Re: Restoration Bay
Case Number: Z/LU-14-09-19
Parcel: 33-30-15-00000-240-0100
RFAI Response #1

RESTORATION BAY
PINELLAS COUNTY, FLORIDA

DEVELOPMENT MASTER PLAN

EXHIBIT B - EVACUATION ZONE OVERLAY EXHIBIT

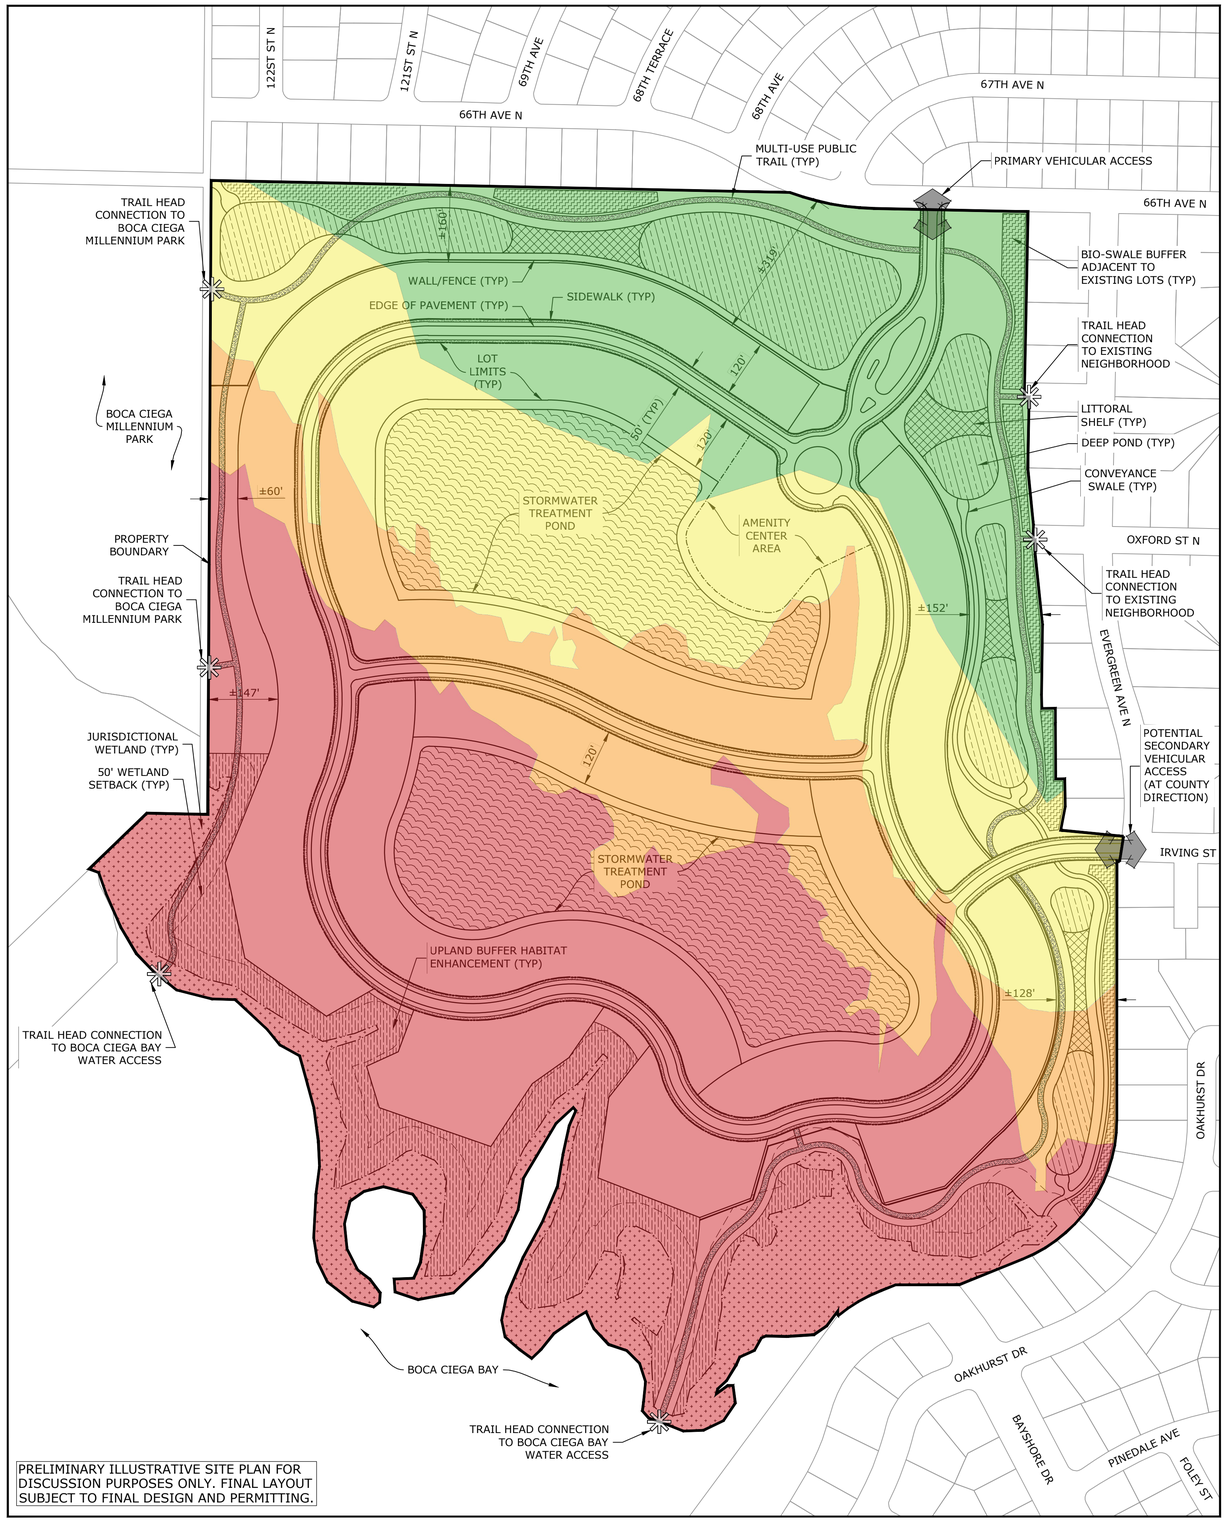
1. Staff Comment: The layout of the proposed Development Master Plan substantially encroaches into and is reliant upon development within the 100-year flood plain, VE zones, and all levels of expected storm surge inundation from a CAT 1 through a CAT 5 hurricane. This expressly conflicts with Comprehensive Plan policies restricting development within the Coastal Storm Area and directing population concentrations out of the Coastal Storm Area.

Again, the overall proposed maximum density of 273 dwelling units is less than 3.0 dwelling units per gross acre, which is less than 60% of the allowed 5.0 dwelling units per gross acre pursuant to Policy 1.3.5 of the County's Comprehensive Plan. In addition to the revised Development Master Plan, the Applicant also has included in this supplemental response an illustrative exhibit which graphically depicts this transition of lot sizes/density from larger lots/lesser density nearest to the waterfront areas, with slightly decreasing lot sizes/increasing densities moving northward away from the waterfront.

EXHIBIT A - MULTI PURPOSE TRAIL EXHIBIT

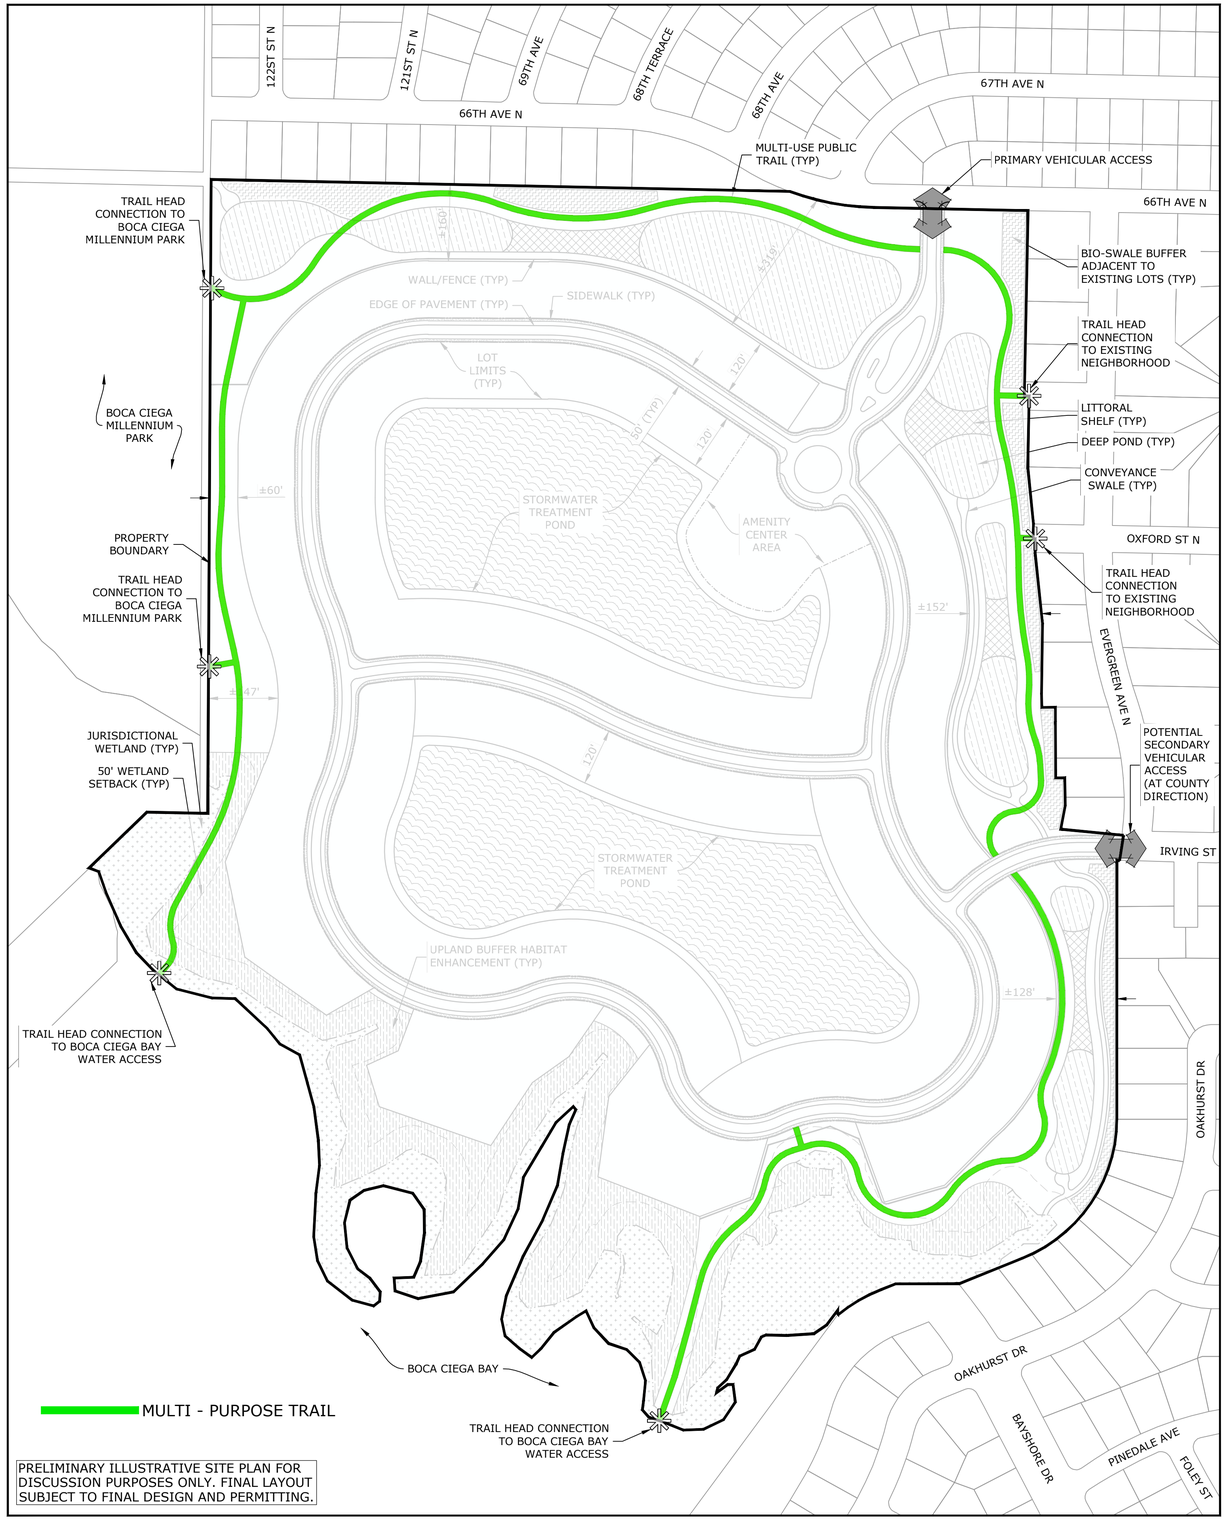
With respect to the last comment re: other multimodal needs in the area, it should be noted that the proposed plan does satisfy previously unmet needs by providing a public access multi-use path around the entire development that connects not only the surrounding neighborhoods to both the County park and the waterfront (which was not possible with the prior golf course use), but also connects the county's neighboring Boca Ciega Bay Millennial Park to the waterfront. This certainly does provide a previously unmet need as the public will have access to the trail and the waterfront. The Applicant also has offered to implement practical and feasible streetscape, sidewalk and safer pedestrian access features along both 66th Ave North and 113th Street North, to which staff previously had agreed as an appropriate mitigation strategy. If staff will identify other specific mitigation measures which are the result of the project's impacts (as opposed to other pre-existing failures/issues), then the Applicant certainly will mitigate them as required by law.

As stated above, the Applicant has proposed to utilize over 35 acres of the property for open/recreation space purposes, including the waterfront dwelling setback area to protect the most vulnerable portion of the project from potential storm impact, and a substantial multi-use trail around the entire development to improve public access to the County park and to the waterfront (public access which was not available previously and which cannot otherwise be provided by the County).

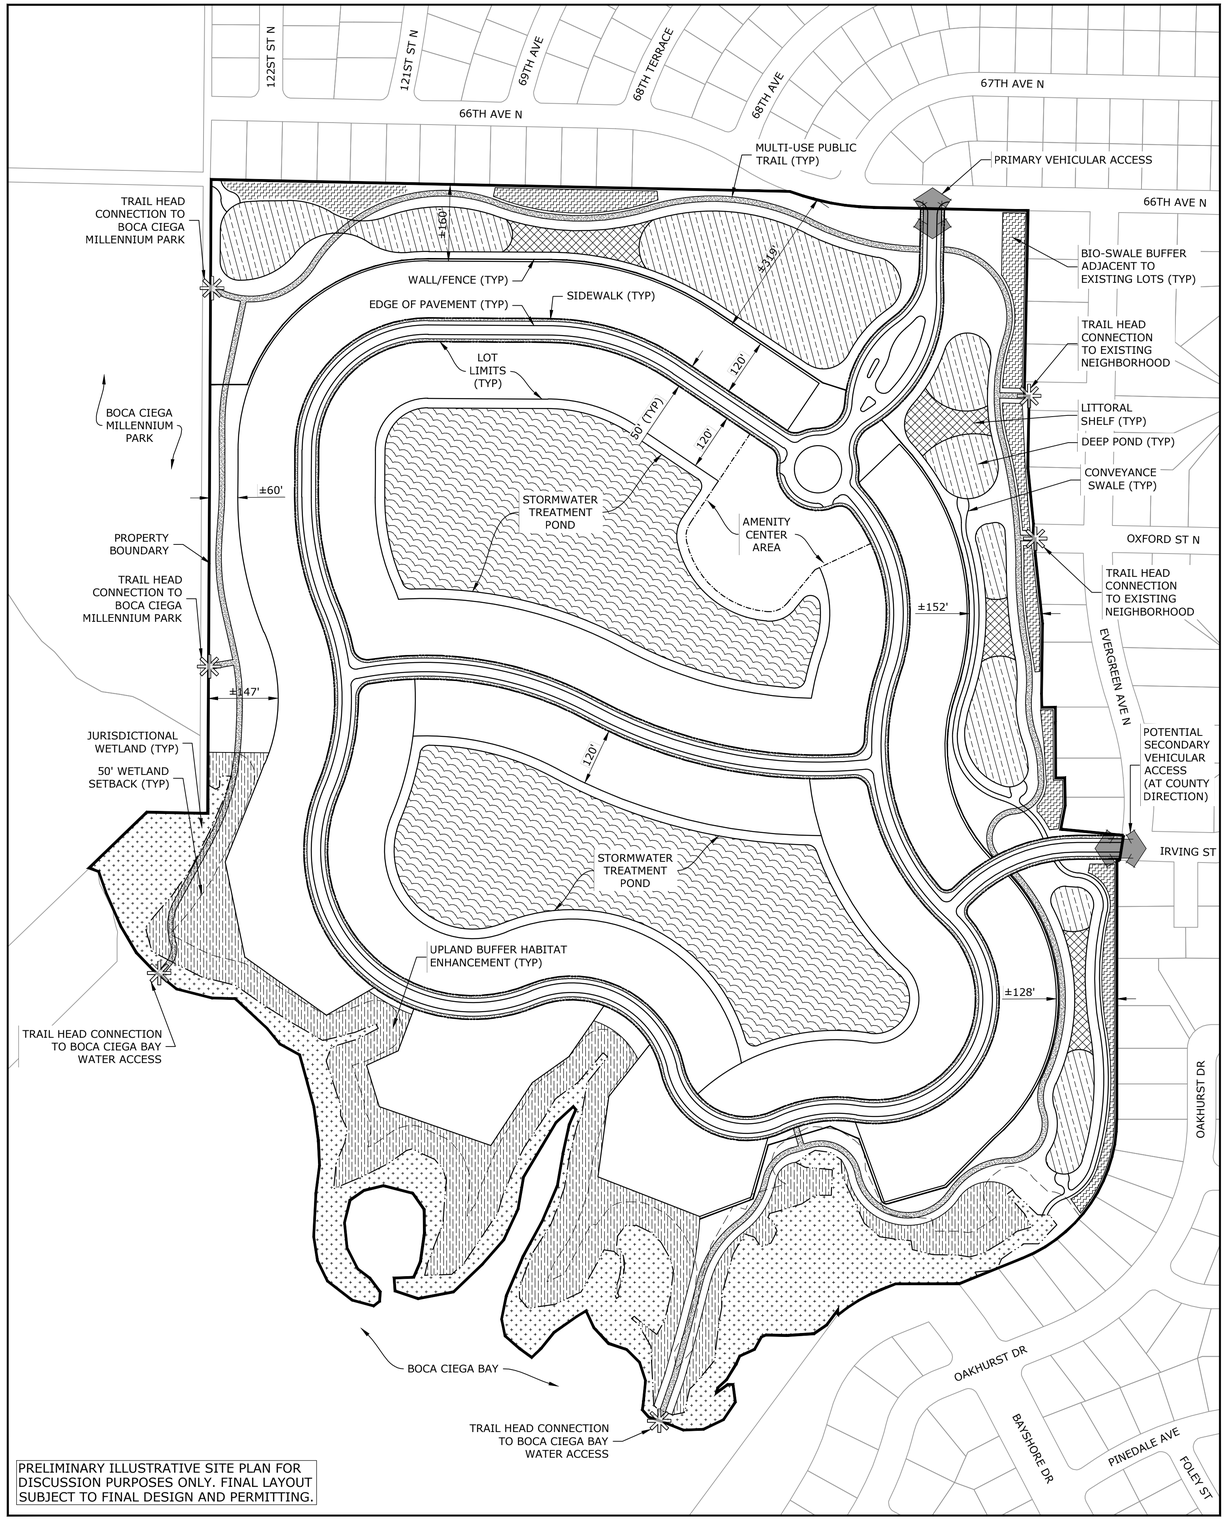
2. **Staff Comment: While the proposed Future Land Use map designation of Residential Low is generally consistent with the surrounding area, the locational characteristics of the category recognize that the more appropriate designation for areas within the 100-year flood plain is Preservation or Recreation/Open Space and that the Residential Low category is only appropriate if Preservation and/or Recreation/Open Space are not feasible, which has not been demonstrated by the applicant.**

3. Staff Comment: The RPD zoning district requires that the district be master planned as a creative, walkable and context-sensitive community that responds to the surrounding land use pattern and preserves unique natural features. Therefore, the Development Master Plan should seek to set aside the more vulnerable areas of the site for preservation/open space uses. The current design does not achieve this, nor does it evaluate and compensate for the impacts of future sea level rise.

5. **Staff Comment: While the overall planned density of 3.1 units per acre for the entire site is consistent with existing surrounding densities, the proposed plan results in internal and external impacts that conflict with the County's Comprehensive Plan policies and established Land Development Regulations.**

6. **Staff Comment: When viewed in its totality, the proposed external stormwater treatment (while clearly beneficial to the area) comes at the expense of not setting aside the most vulnerable areas of the property for preservation/open space, and places residential development in these areas instead. On balance, the public benefit does not outweigh the overall impacts of the development and the loss of recreation/open space and preservation uses on the property.**

Notwithstanding the foregoing Comprehensive Plan policies which clearly authorize and allow the Applicant's proposed single-family density in the coastal storm area (at 5.0 dwelling units or less per gross acre), the Applicant nevertheless has voluntarily revised its proposed Development Master Plan in a good faith effort to respond further to staff's prior recommendation and comments, and to enable staff to reconsider its erroneous findings and recommendation. Consequently, the Applicant has enclosed a revised conceptual master plan which now provides for a graduated, transitional mix of dwelling lot sizes to:

(i) provide a substantial building setback buffer between the southern waterfront and any residential dwelling development area;

(ii) increase lot size and reduce density in most southern dwelling development areas closest to the southern waterfront dwelling buffer area; and

(iii) then transitioning within and from each respective storm surge area and the corresponding Hurricane Evacuation zones to greater density as the project transitions northward away from the waterfront area.

Thus, the plan not only provides for a density of less than 3.0 dwelling units per gross acre (substantially less than the allowable 5.0 dwelling units per gross acre), the revised plan also now concentrates and directs most of that density inland.

For example, not only does the plan provide for a substantial (approximately 50-feet wide min.) voluntary dwelling building setback buffer along the entire southern waterfront area, but the plan then also then provides for lots having a minimum width of 100' in the outer (southern) development edge, with gradual transitioning of lot widths to slightly higher densities moving away (northward) from the waterfront dwelling buffer area.

For example, there are substantial open/recreational space areas provided on all four (4) sides of the proposed residential dwelling area; this amounts to **35 acres** (which is 36% of the land within the project) of open/recreation space in the locations most consistent with the "appropriate" locational characteristics: (i) adjacent to the Boca Ciega Millenium Park on the west boundary; (ii) adjacent to the comparable and consistent residential subdivision to the north; (iii) adjacent to the comparable and consistent residential subdivision(s) to the east, and (iv) the substantial dwelling setback buffer along the Boca Ciega Bay waterfront on the south. Additionally, the Applicant has met any legitimate request for public open/recreation space through its commitment to provide a 1.2 mile long multi-use public trail which connects to/from the Boca Ciega Millenium Park, extends around the entire project boundary, and connects to the Boca Ciega Bay Water Access/Trail Head. This will ensure that the public has recreational amenity access for everyone, while preserving the private home ownership and security/safety of the project residents whose dwellings will be concentrated in the interior of the property. This public access was not available and was not allowed under the prior golf course operation on this property; hence this confers a significant new public benefit.
